ABINGTON TOWNSHIP

PLANNING COMMISSION MEETING

a. Review the Final Major Land Development application LD-23-01 for the location at 711 Fox Chase Road, Jenkintown, PA 19046. (St. Basils).

VEHICULAR CIRCULATION PLAN
Scale 1"=100'

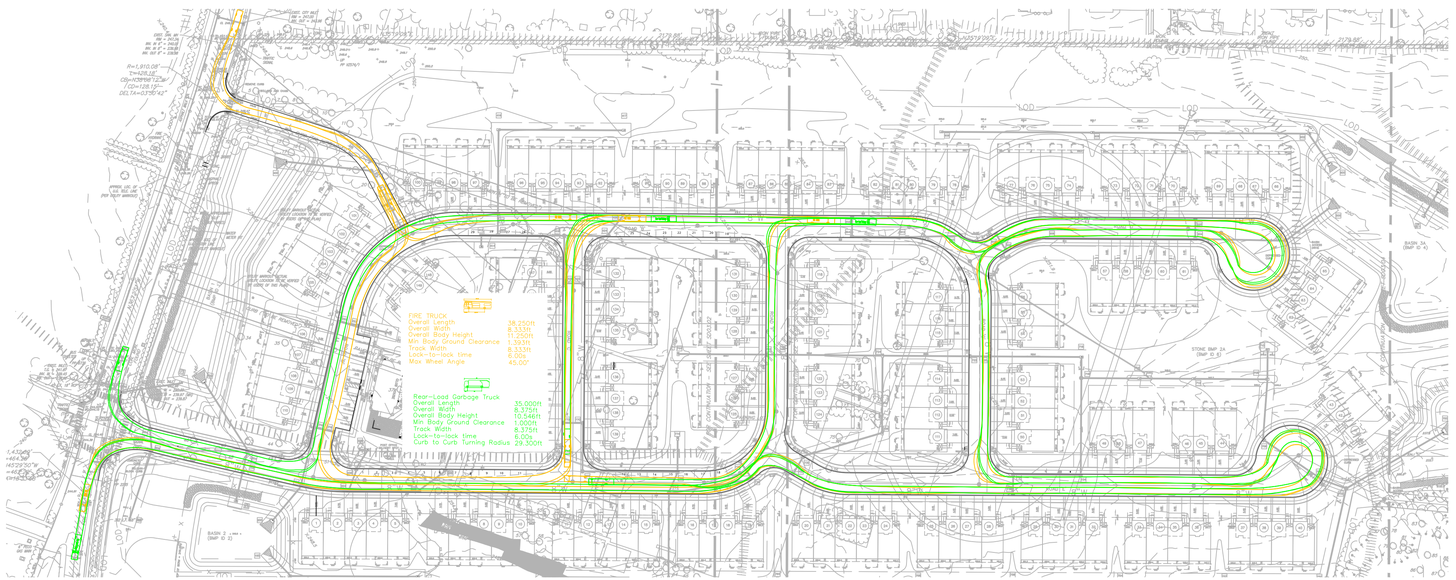
1. Withing the "Full Plan Set" document, on page SD02.01 (sheet 6 of 64), there is General Note 29-D2 which states "FIRE HYDRANTS SHALL BE SPACED IN A DEVELOPMENT SO THAT ALL PROPOSED BUILDING(S) WILL BE NO MORE THAN SIX HUNDRED (600) FEET FROM THE HYDRANT MEASURED ALONG TRAVEL WAYS."

ESE Response: The applicant has updated Sheet 6, SD02.01, to include a vehicle circulation plan for an emergency vehicle (fire truck) and refuse collection truck.

ESE Response: The applicant has updated Note 29 on Sheet 6, SD02.01, to state Fire hydrants shall be spaced in a development so that all proposed building(s) will be no more than five hundred (500) feet from the hydrant measured along travel ways.". This will keep the plans in compliance with SALDO 146-41 B(4)d as none of the fire hydrants proposed are temporary and are spaced as 500 feet of less per the requirement.

EXISTING FEATURES PLAN/ERSAM
(SHEET 1 OF 4)

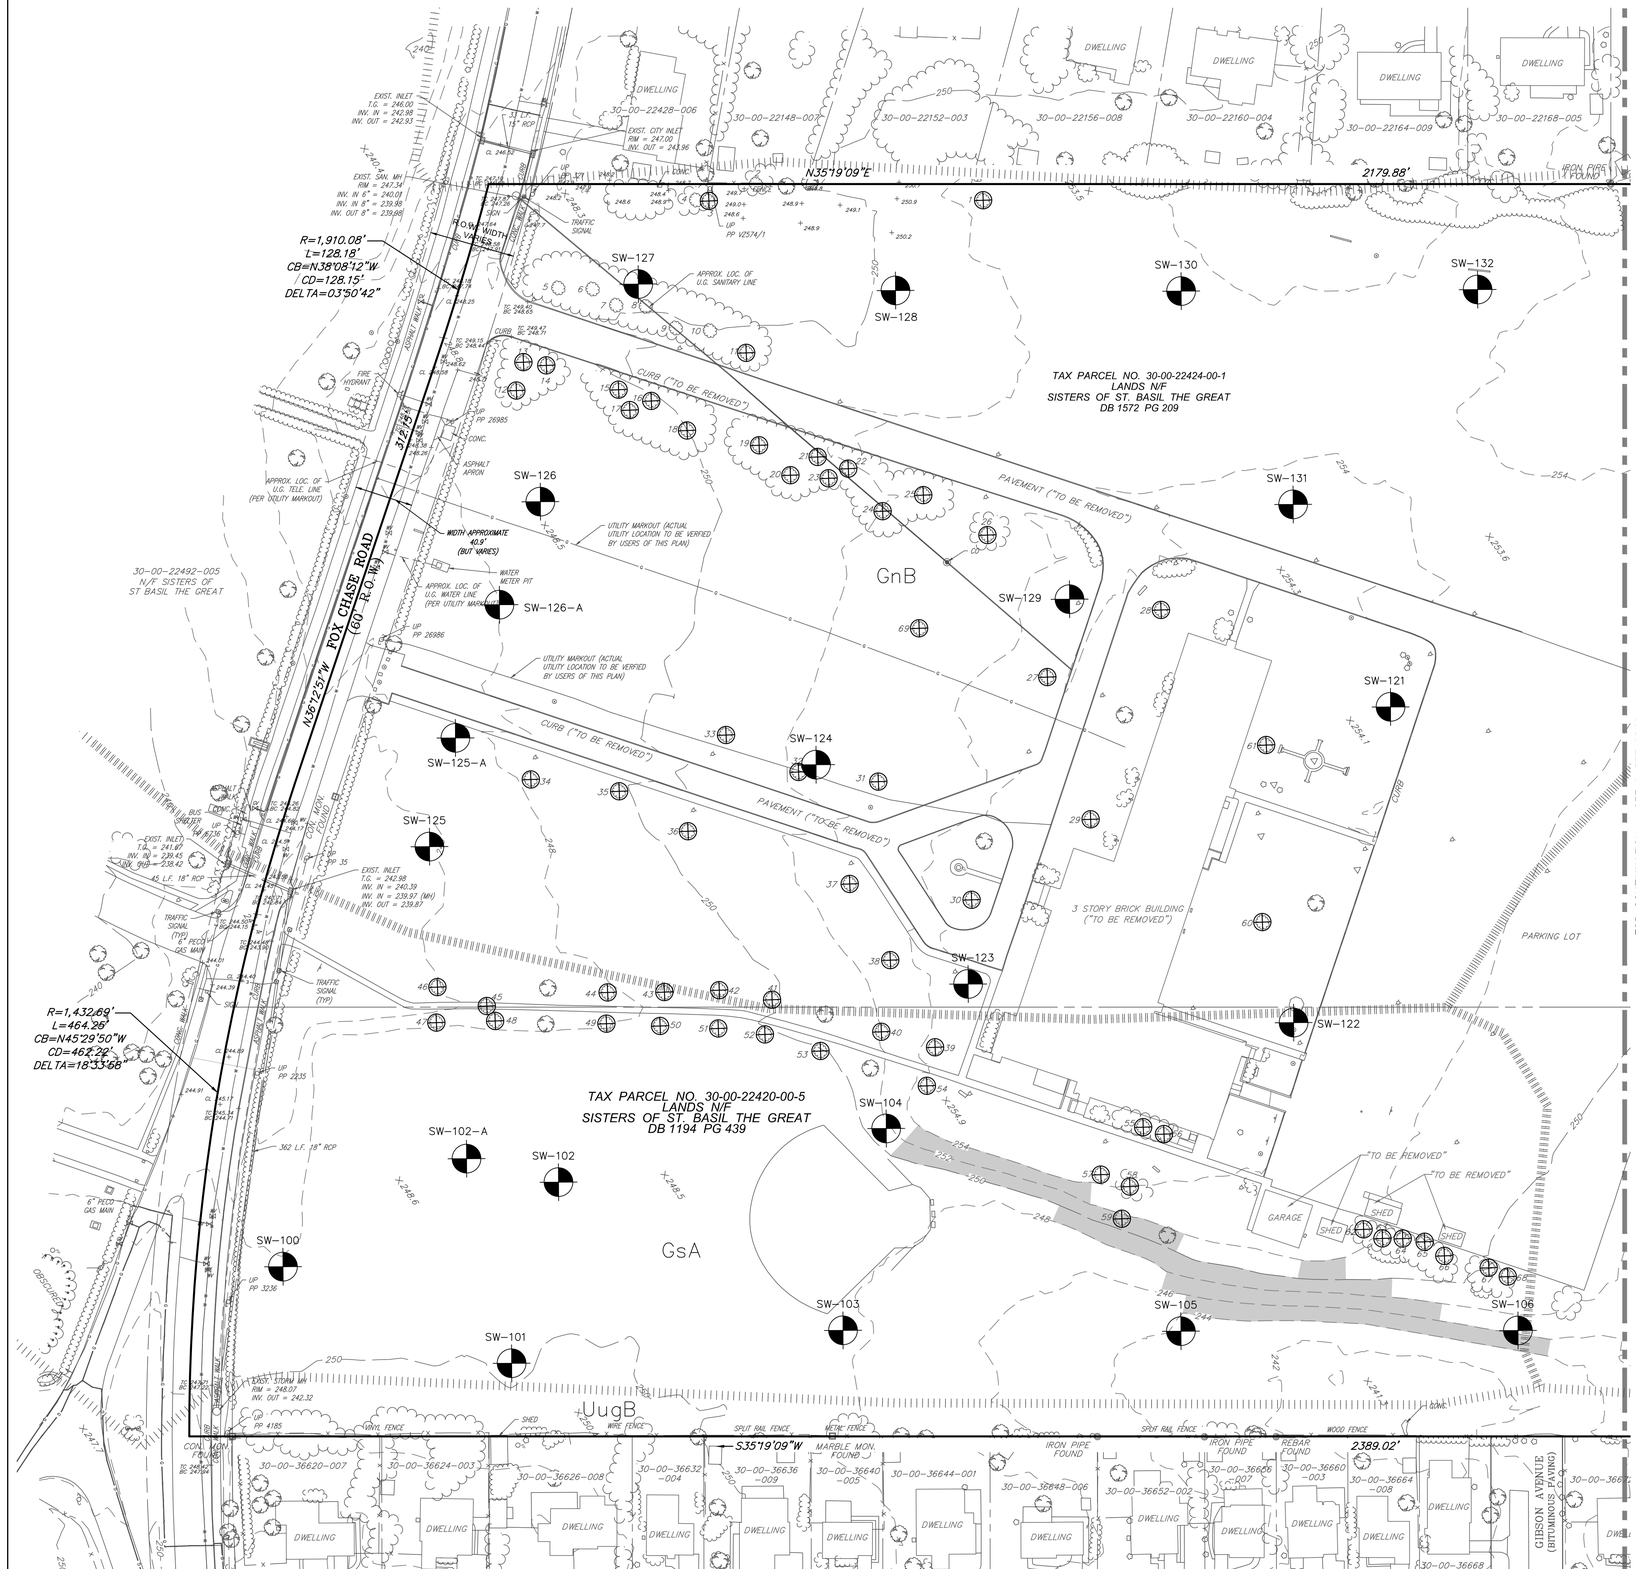
80. *Per the Existing Features Plans (Sheets 7 to 10), there are multiple locations where private fencing and structures are shown to be encroaching within the site boundaries from the abutting properties that front Forrest Avenue, Kirkwood Street, and Suffolk Road. The Applicant shall clarify if the private fences and structures are permitted to remain or be required to be removed outside the site boundaries. It is recommended that a written agreement to permit these encroachments for each of the properties should be provided to the Township.*

EXISTING FEATURES PLAN/ERSAM
(SHEET 2 OF 4)

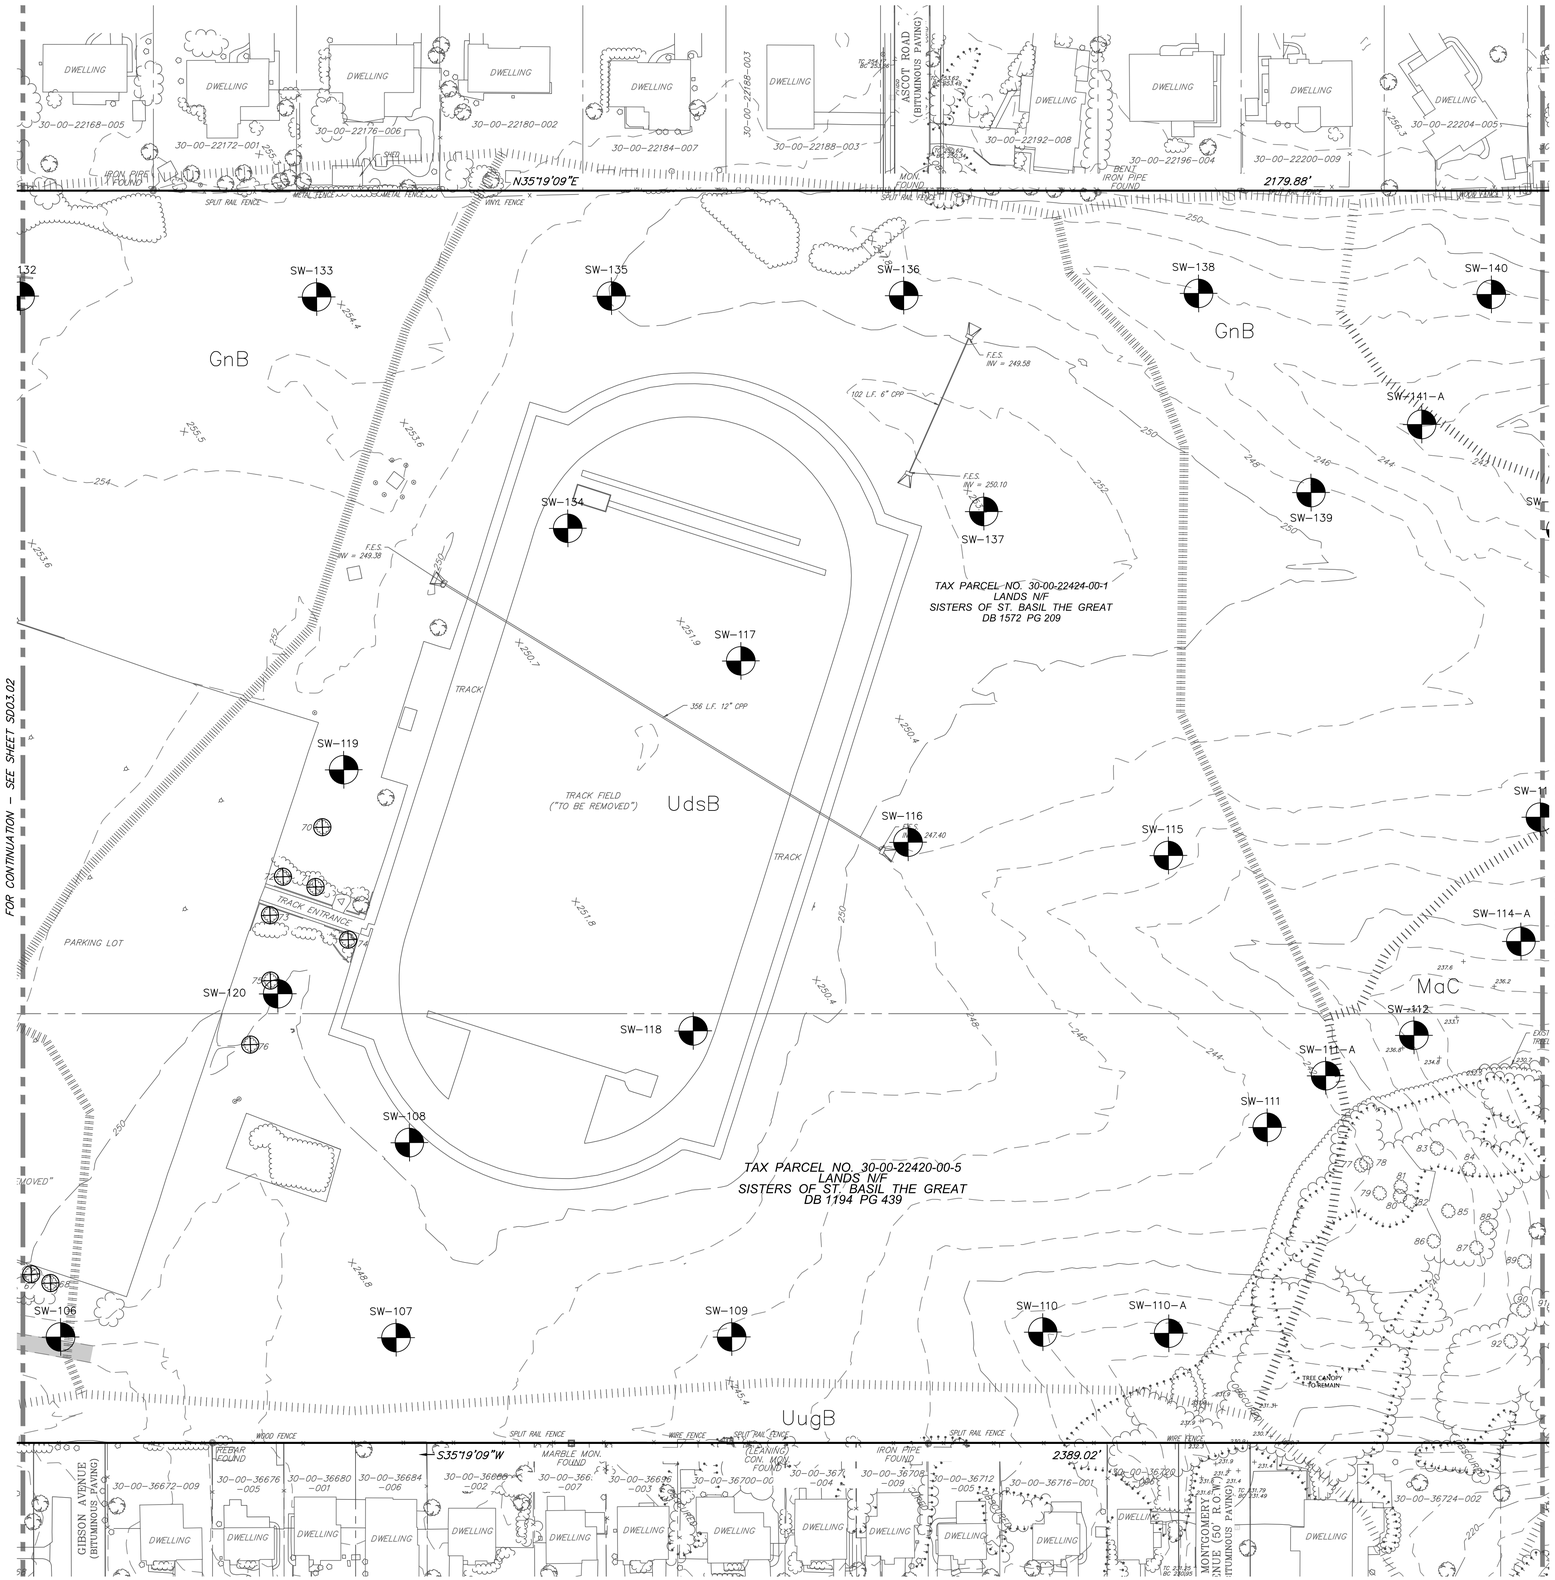
1. Existing Features Plan - Sheet 8 of 64, Sheet 2 of 4
According to the construction designation chart showing existing trees of 10" diameter or more, Tags # 1 and #3 – are to remain. We recommend removal of these trees as these are Tree of Heaven, an invasive tree species known to be critical in the Spotted Lantern Fly life cycle. Tag 84 – indicates removal of a large beech tree for a sewer line easement – See also, Sheet 62. If this is a healthy tree, we request that placement of the easement be re- evaluated to avoid removal of this tree. Can the developer please explain the rationale for the proposed placement?

ESE Response: The existing features plans have been updated, tree #1 and #3 to be removed. Tree #84 will remain; the proposed drainage easement has been relocated to avoid tree removal. See sheet 8 of 64 for the existing tree chart and their designation whether to remain or to be removed.
The sewer line easement has been revised to avoid the removal of the large beech tree (tag #84).

ESE Response: Sheet 8 shows the existing tree chart and their designation whether to remain or to be removed.

DATE: 3-24-23	SCALE: 1" = 100'
DESIGN:	DRAWN: EJS
JOB NO.: 7662	FILE NAME: 7662-S-04-SITE
REF. NO.: **SD04.01**	
SHEET NO.: **11** OF **62**

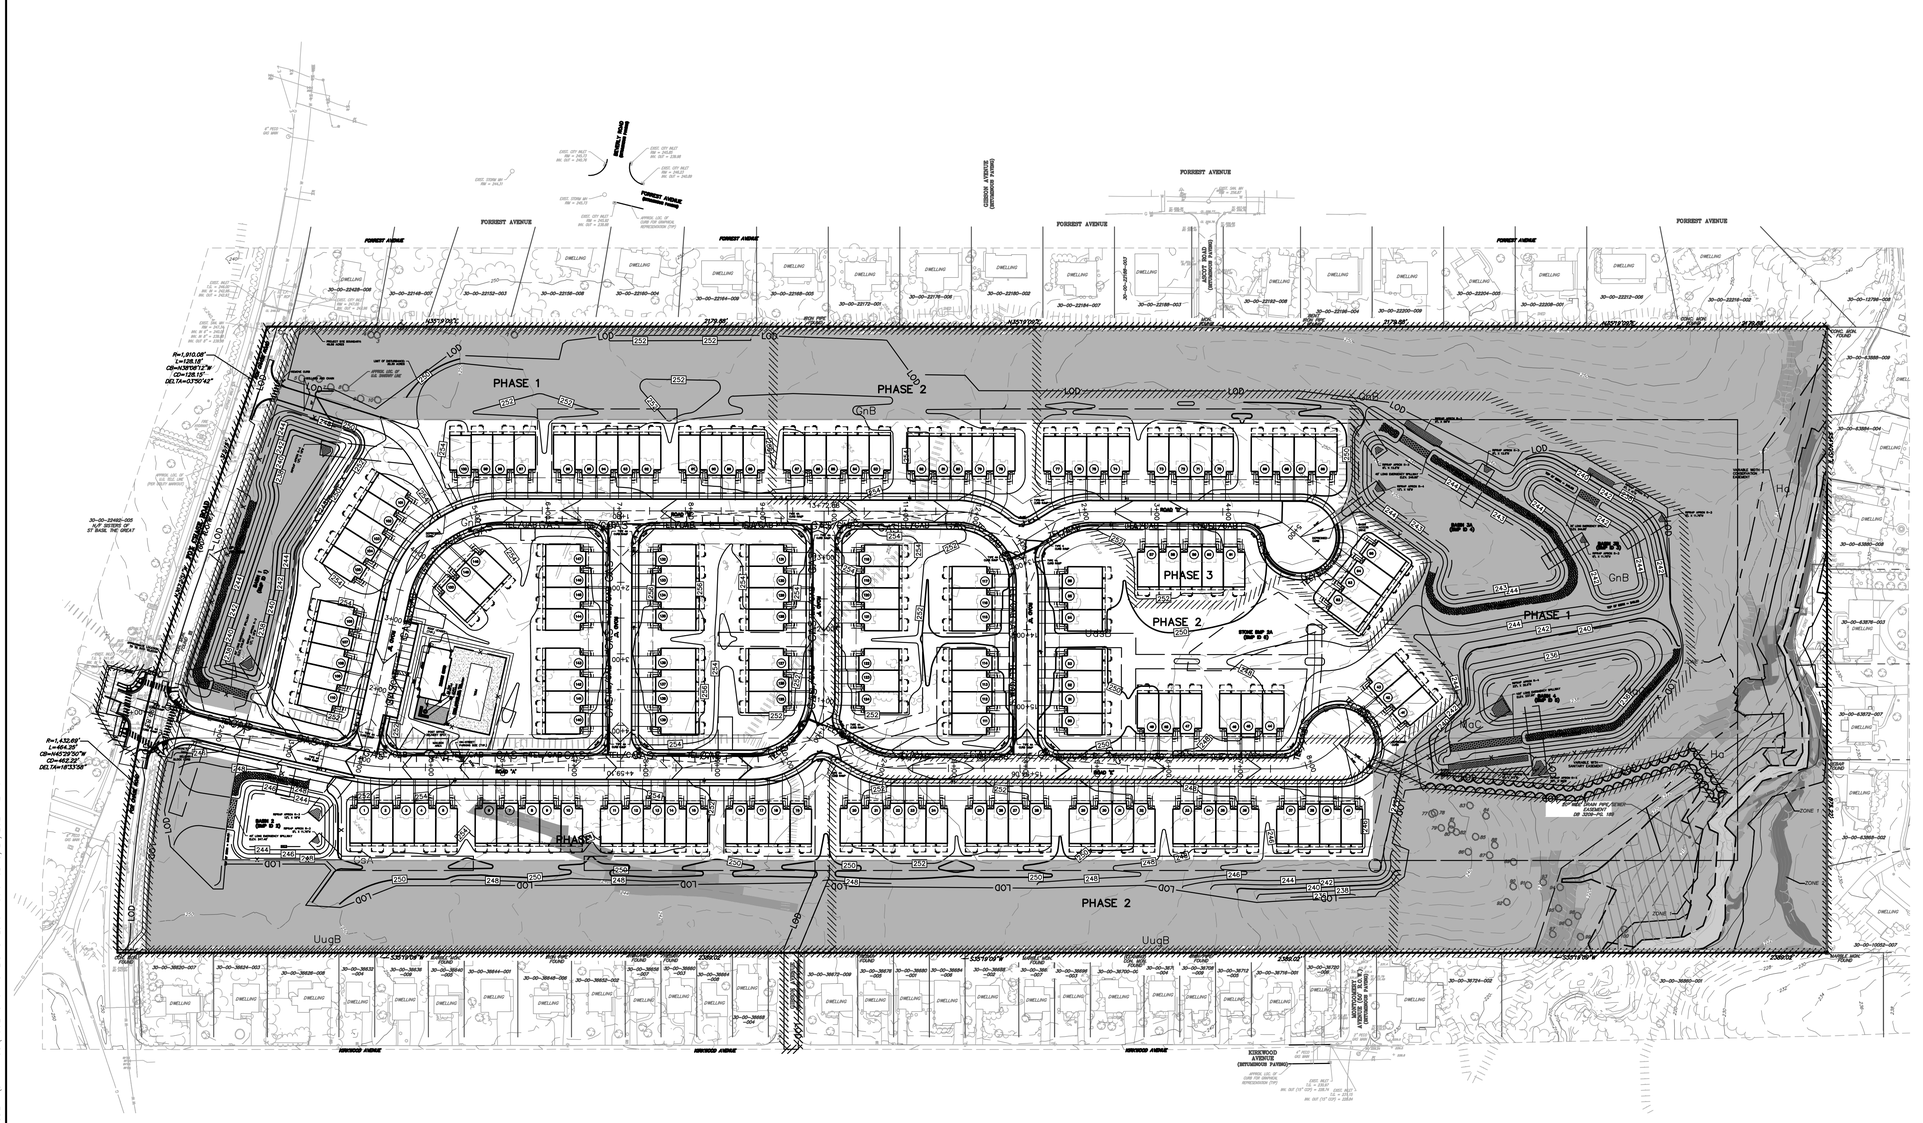
The Applicant is showing the proposed open space on the Overall Site Plan (Sheet 11) and has provided the open space calculations on the Record Plan (Record Sheet 2 of 4). However, there is discrepancy between the open space calculated in the Area Tabulation (39.694 Ac) and the open space acreage given in the Zoning Table (22.6 Ac). The discrepancy shall be confirmed and revised to be consistent on both plan sheets.

ESE Response: The qualifying open space is hatched on the overall site and phasing plan, on sheet 11, the hatched area does not include the required yard areas. The green area is an overall calculation subtracting the proposed impervious area from the gross site area, which includes the qualifying open space.

ESE Response: Sheet 11 the overall site and phasing plan hatches the qualifying open space in accordance with the applicable zoning requirements.

ESE Response: Sheet 11 the overall site and phasing plan hatches the qualifying open space, which does not include rear, side or front yards of the dwelling units.
